Tree report P 080.100 v3a

09 April 2025

**Conway Park
Consolidated tree report**

Figure 3, tree protection fencing from ACD

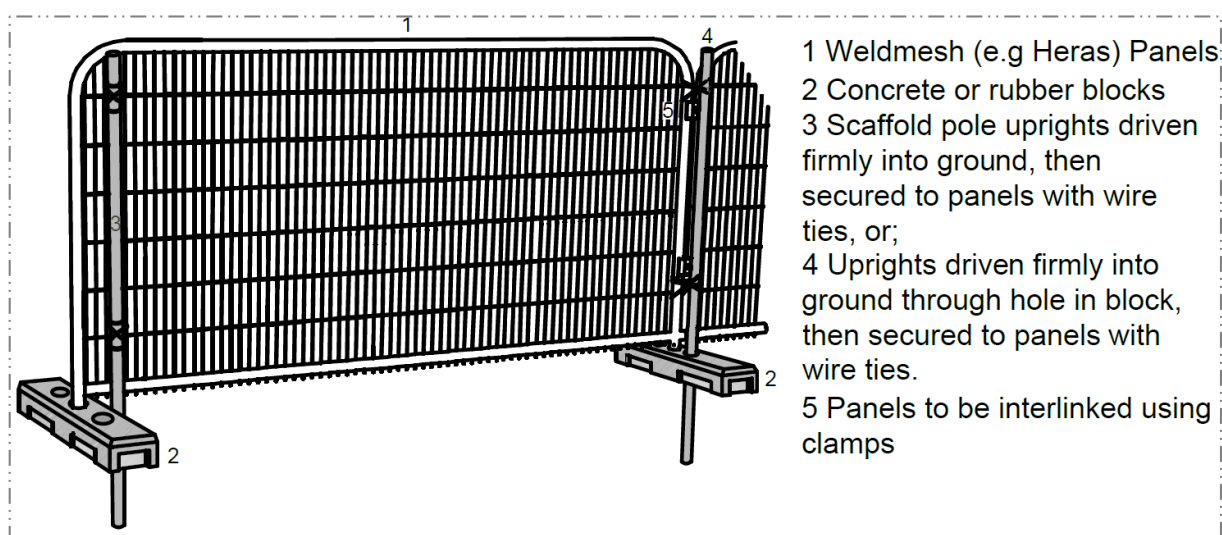
42 ACD proposed an alignment for the protective barrier fencing without identifying which trees would need to be removed to facilitate the construction of the access road and tunnel, and so the identification of the necessary tree losses was deferred until the final alignment had been agreed. Their proposed alignment related to the completed built form and made no allowance for the working space required to construct the road or to excavate the tunnel.

43 The specification for the temporary protective barrier fencing to create the CEZ was shown on the TPPR&T, reproduced in figure 3 below:

44 Therefore, the TPPR&T was incomplete as it did not reflect the working space required to construct the access and the tunnel.

Figure 4, an annotated extract from the RTPS from FDA

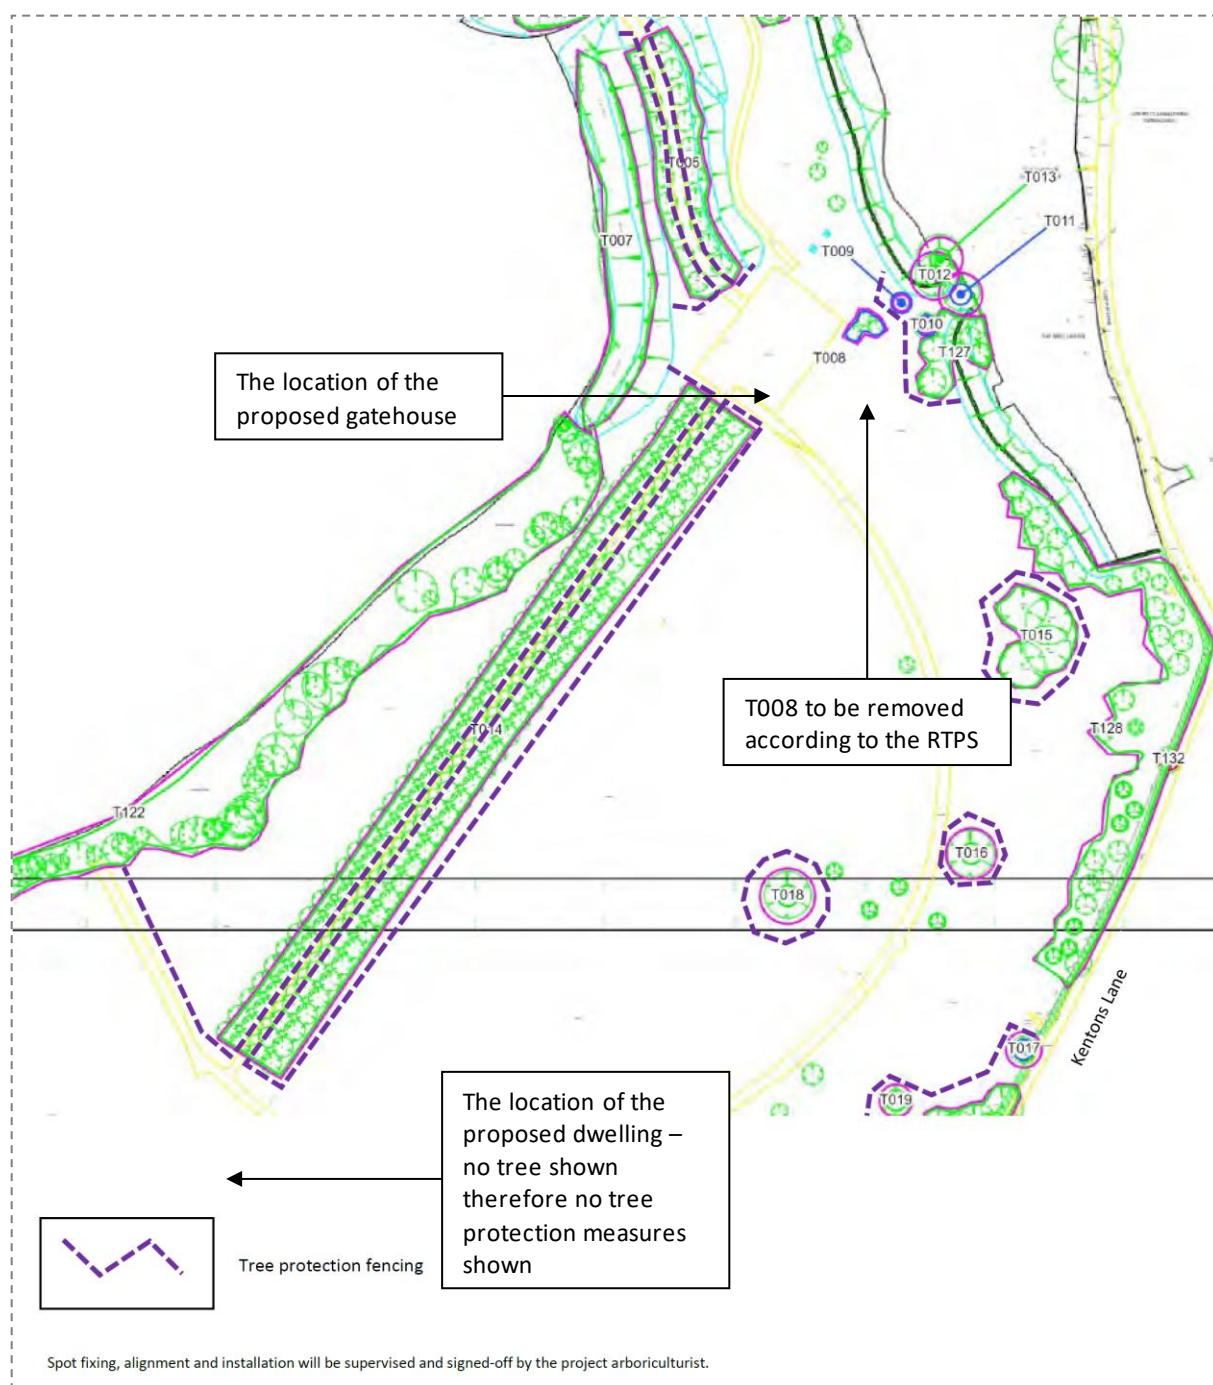
- 46 The RTPS shows the tree allée, individual trees, and tree groups some distance from the footprint of the proposed dwelling, as well as T008 identified for removal from adjacent to the proposed gatehouse, and includes the alignment of protective barrier fencing around each retained arboricultural asset to exclude site traffic from the soil at the trees' bases, see figure 4.

- 47 Notwithstanding the discrepancies between the landscape as shown on the RTPS and the evolving landscape, the tree protection recommendations with the RTPS as they pertain to this application would seem to be sound.

Figure 5, the RTPS by FDA

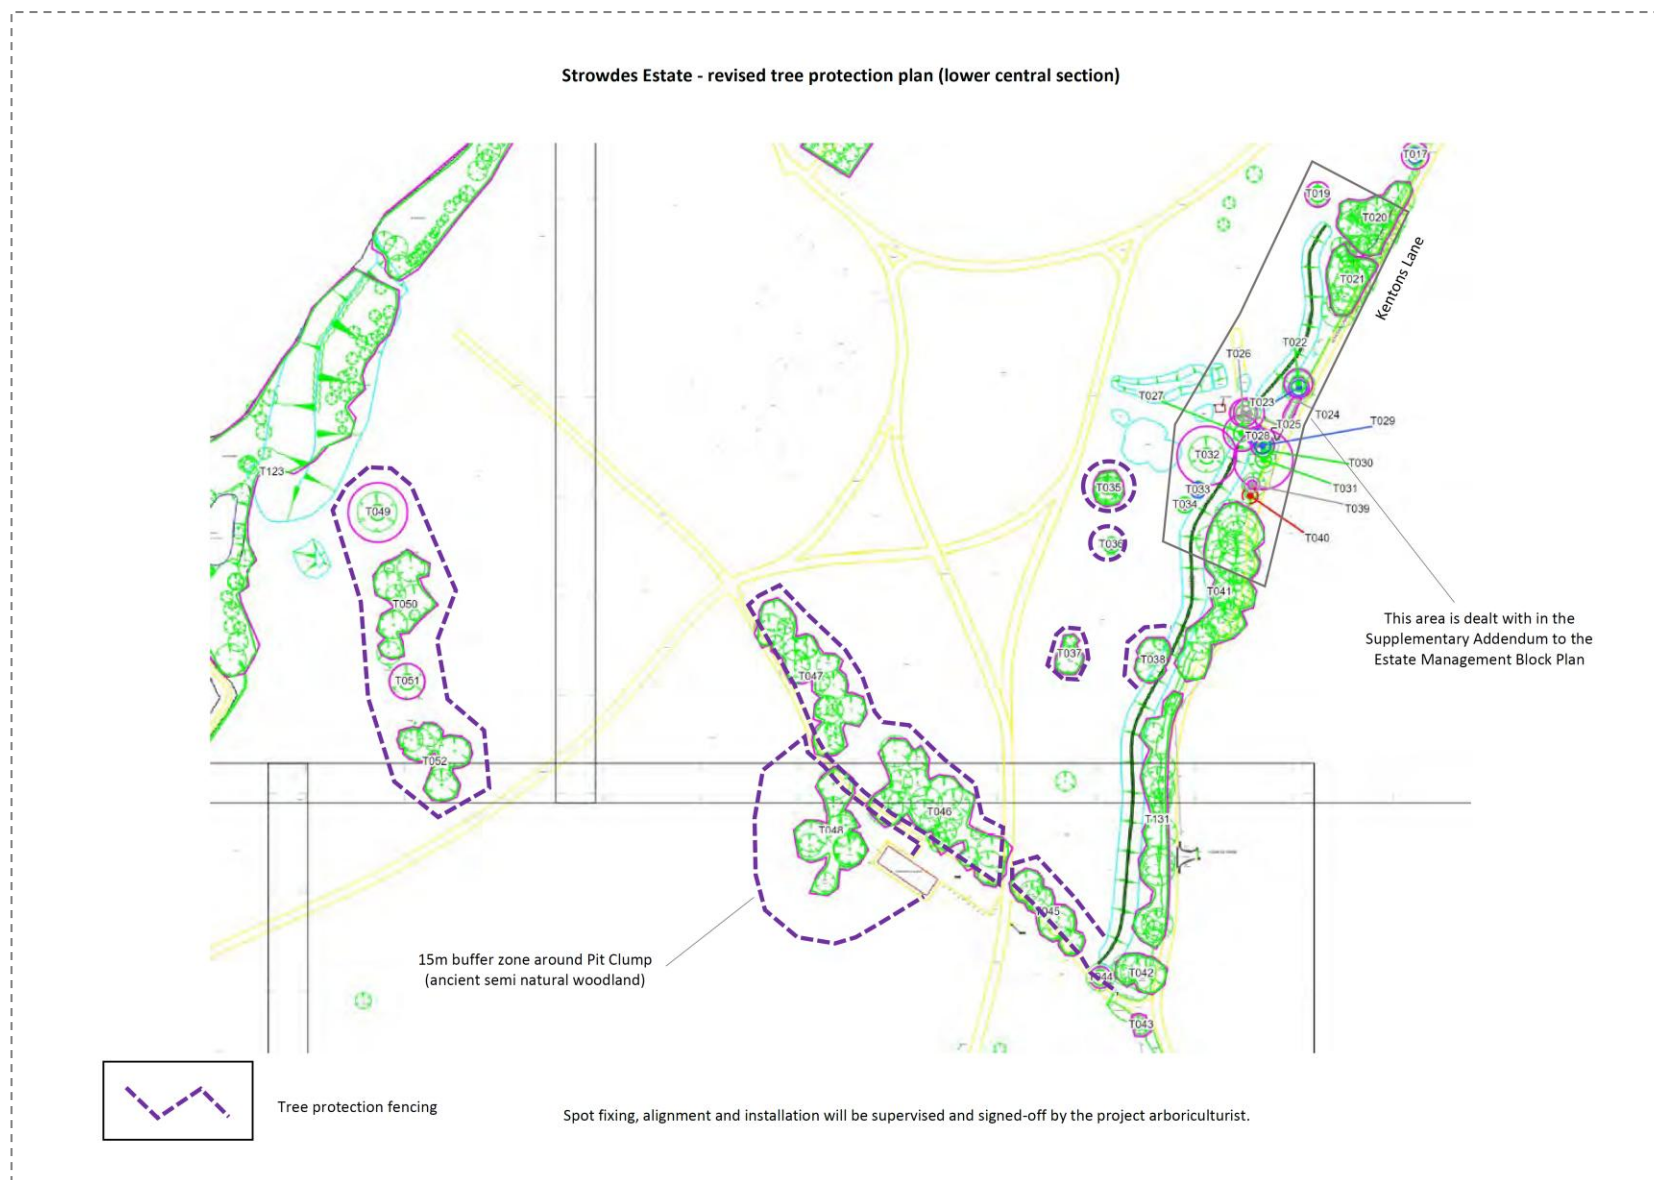
- 26 However, the RTPS has been reviewed as the PLM has been superseded, and the RTPS was also (not unreasonably) silent upon, amongst other issues, the consequences of the need to divert services within the site.

- 27 In contrast to the broadbrush approach of the RTPS the red line boundaries for each application site were drawn very tightly around the footprint of each of the five development sites.

- 29 However, the RTPS proposed the erection of several discrete **Construction Exclusion Zones** (CEZ) to the default specification of BS 5837 across the site for the duration of the development, which, whilst effective, would be visually intrusive and lead to grounds maintenance issues.

- 32 Therefore, whilst the RTPS is considered adequate to discharge the conditions attached to applications 213587 and 213588, it is not appropriate for the wider site as it does not reflect the current situation, and so a revised scheme of tree protection has been prepared.
